NUCLEAR CONTAINMENT FAILURES:

Ramifications for the AP1000 Containment Design

Fairewinds Associates, Inc wrote *Nuclear Containment Failures: Ramifications for the AP1000 Containment Design*, December 21, 2010, in order to:

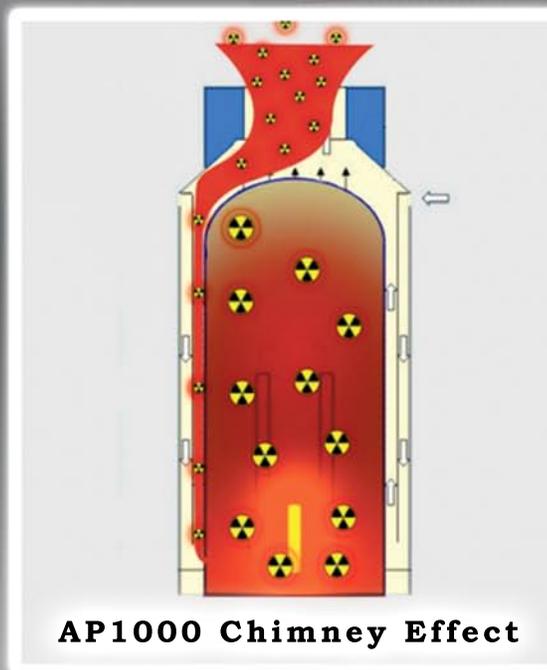
On June 28, 2010, three days after the ACRS meeting, Fairewinds Associates, Inc informed the ACRS of *yet another containment failure*, this time at the Fitzpatrick nuclear power plant in 2005. The photo below of the 4 ½” crack was taken in 2005 from the outside of the containment torus at the Fitzpatrick nuclear power plant in Oswego, NY.

As a result of questions during the ACRS discussion period relating to BWR thick containment designs like the through wall cracks at Hatch 1 and 2, Fairewinds researched additional failures and found that the Fitzpatrick nuclear power plant developed a large through-wall leak that was not due to corrosion. Once again, here is a unique violation of the BWR containment system that is directly applicable to the Westinghouse design of the AP1000.

The Fitzpatrick crack is due to differential expansion in a thick containment that is of similar thickness to the proposed AP1000 design and like the cracks previously uncovered at Hatch 1 and Hatch 2. Thus to date, three thick containments have experienced complete through-wall

failures that remained undetectable by ASME visual techniques until each through-wall crack actually appeared.
